project 5-17 Flemington Road, North Melbourne

## MINISTERIAL PLANNING REFERRAL DELEGATE REPORT

<b>Application no:</b>	TPM-2022-10 (PA2201602)
<b>Applicant:</b>	Urban Planning Collective
<b>Owner:</b>	Centurion Australia Investments
<b>Architect:</b>	Architectus and Metier3
<b>Address:</b>	5-17 Flemington Road, North Melbourne (RMIT Village)
<b>Proposal:</b>	Use of the land for retail premises, medical centre and accommodation (student housing), to construct a building and construct or carry out works, a reduction in car parking requirements and alteration of access to a road in a Transport Zone 2
<b>Cost of works:</b>	\$264,330,000
<b>Date received:</b>	26 April 2022
<b>Date amended:</b>	7 August 2023
<b>Responsible officer:</b>	Lachlan Orr, Principal Urban Planner

**Figure 19: Streetscape elevation illustrating varied street wall heights along Bedford Street (left) and Blackwood Street (right)**

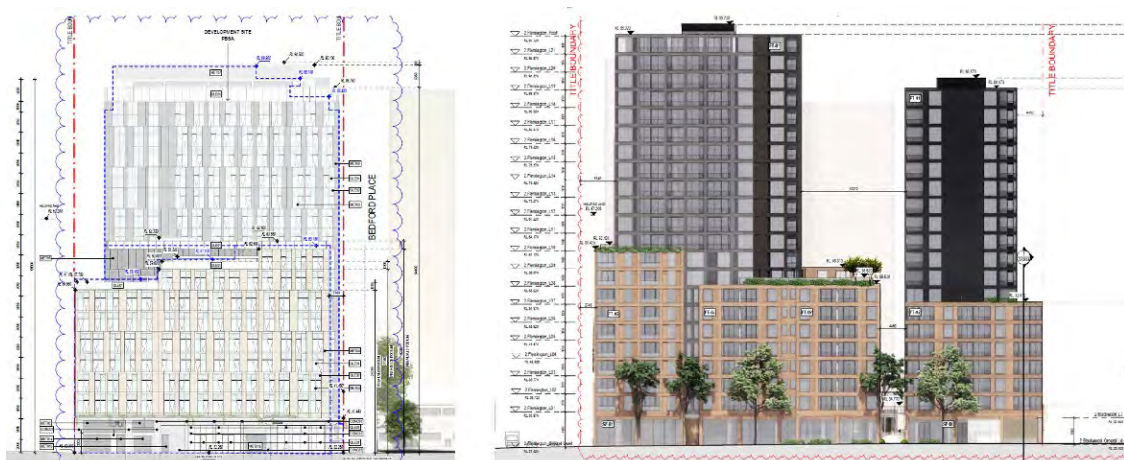
This approach does not strictly conform to the DDO61 envelope, requiring either a 10m setback (Area 5) or 45 degree line above the street wall, but is an appropriate response to the transitional location of the site and the built form outcomes listed above. The massing of the street wall and upper level setbacks provide an appropriate response to the corner context and the significant building forms which characterise Flemington Road. Additionally, the lowering street wall heights and increased front and side setbacks provided to the tower forms ensures a meaningful internal separation and visual relief is provided to the public realm.

The Stage 1 building is located entirely in Area 2 and has a staggered street wall height ranging from 24.29 metres to 30.39 metres. Above the street wall, the tower has a setback of 26.67 metres to Bedford Street. This generally accords with the 45 degree setback line. The sections of street wall exceeding 24 metres generally accord with the 1:1 building height at street edge to street width ratio on Bedford Street (30m wide), which is contained within the design objectives for DDO61.

**Figure 22: Shadow analysis on 21 June showing existing shadow (blue), proposed shadow (red) and allowable shadow (green) in relation to Bedford Street Reserve**

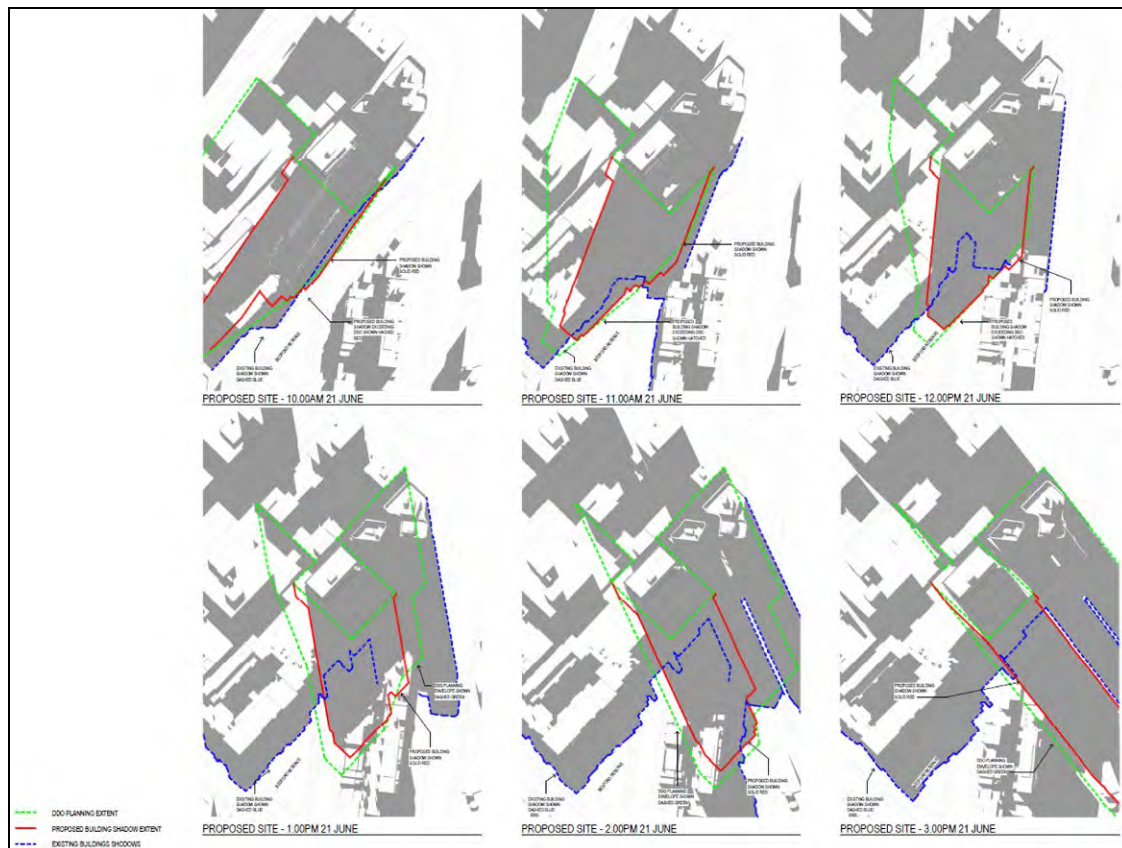
Having regard to these factors, the extent of shadow cast by the proposal would comply with the requirements of the proposed DDO8 under Amendment C415 as it

does not exceed the 'existing' or 'allowable' shadow cast on Bedford Street Reserve on June 21 between 10am and 3pm. A condition of permit will require the provision of updated shadow diagrams with plans submitted for endorsement to ensure this outcome is maintained.

**Figure 23: Marked up plan illustrating additional setback from south-western boundary**

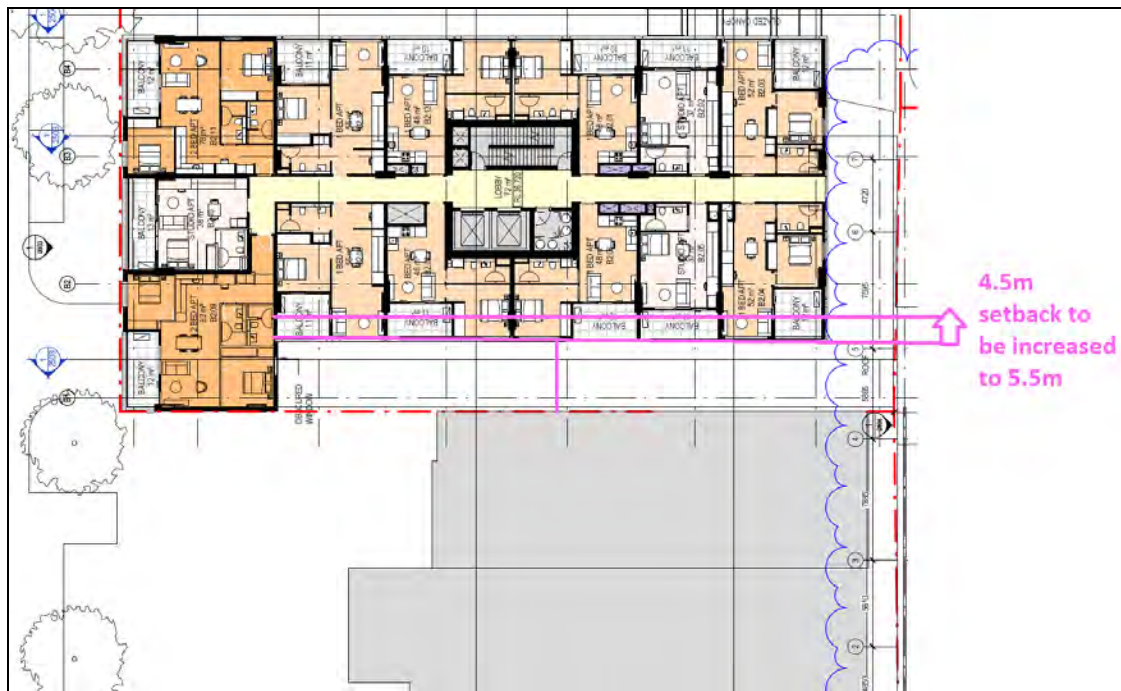
A setback of 4.5 metres is provided from the southern apartment tower to this interface, which suggests a reciprocal setback of 4.5 metre on the neighbouring property to achieve a combined 9 metre separation to limit cross-views. Whilst this approach has merit, it is considered that the comparatively limited size of the neighbouring site suggests that it should provide a lesser setback than the subject site.

The permit applicant has responded to this with an offer of an additional 1 metre setback from the south-western boundary, taking the overall setback of the southern apartment tower to 5.5m. Returning to the reciprocal setback approach, this would result in a 3.5 metre setback being provided on the south-western neighbour. This outcome is considered to achieve an improved equitable development for both sites and will be addressed through a recommended condition.

**Figure 25: Level 8 and 10 terraces and roof terrace where conditions are recommended to enhance functionality**

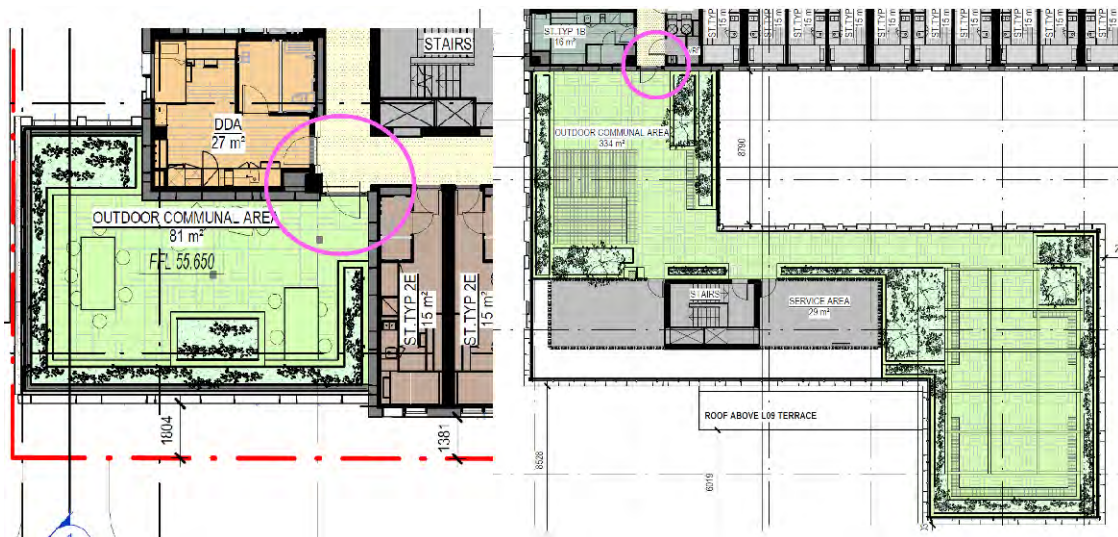
- While falling short of the total of 1,610 square metres (2.5 square metres per student) encouraged by the policy guideline, the communal outdoor space provision is considered to adequately meet the recreational needs of students. Additionally, the surrounding area includes a number of public open space areas including University Square (300 metres east), Lincoln Square (500 metres east), Bedford Street Reserve (60 metres south) and Royal Park (650 metres north-west) which are readily accessible to future occupants.

- Where communal outdoor space is provided, it will generally have an appropriate interface with internal common areas. This is not the case for the south-east terraces at levels 8 and 10, facing Bedford Street, which are accessed by a single width doorway located between a single and twin student room. A condition of permit will require the provision of a lounge or similar communal space which will have a direct interface to the external terraces and achieve an adequate level of function, safety and passive surveillance.

Figure 27: Studio apartment balcony requiring a variation to Standard D19

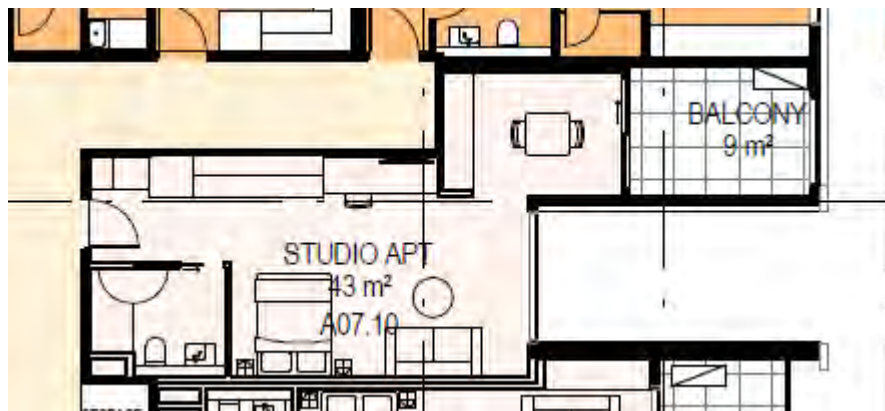
The majority of balconies and terraces to each dwelling achieve compliance with the requirements of Standard D19 in relation to their area, minimum dimensions and layout. However, there is one studio apartment on Levels 1 to 7 of the northern apartment tower which falls short of the standard. A total area of 9 square metres is provided, falling short of the 9.5 square metres required by the standard due to the accommodation of the heating/cooling unit. A variation is considered acceptable as the 0.5 square metre shortfall will not unreasonably detract from the recreation and service needs of future residents.

**Figure 28: Indicative staging plan (left) and completed access plan (right) showing the Stage 2 proposed pedestrian through link in light green**

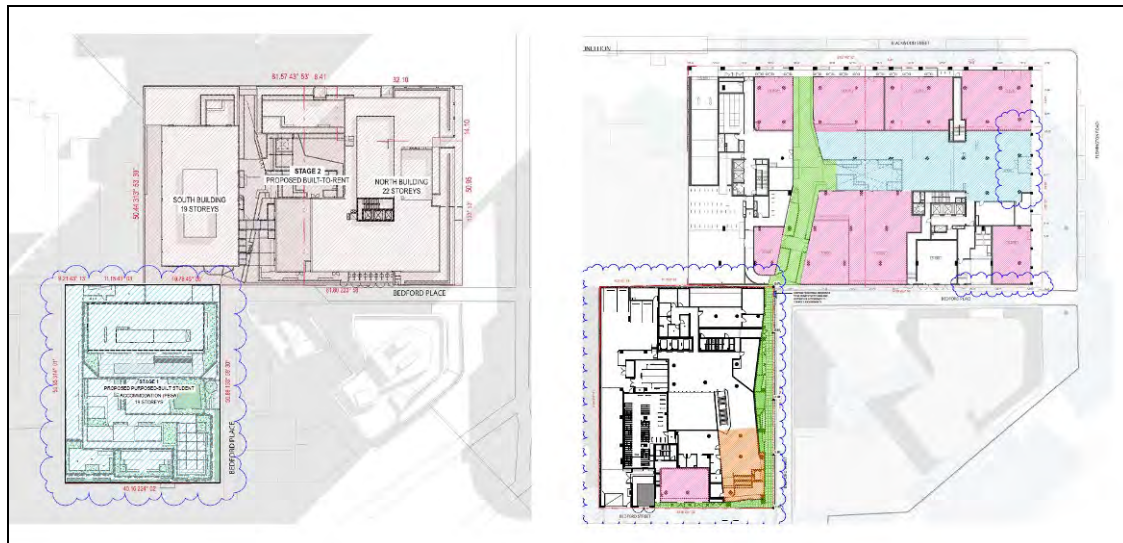
Managing the existing student housing uses, and associated Section 173 Agreements, on the Stage 2 site is of relevance to both the interim and completed development outcome and is recommended to be addressed through permit conditions relating to these agreements as discussed under the Land Survey comments in Section 6 above. Through the recent amendment of the plans associated with TP-2015-1024, there is no conflict or reliance on land within Stage 1 for the existing student accommodation use to continue.

A permit condition is recommended which will require the approval of a Staging Plan prior to the commencement of works. Any Staging Plan approved under the permit would be capable of being refined or amended as required through the development of each stage. A condition will also be recommended for a Section 173 Agreement to ensure the completion of each stage of the permitted development.
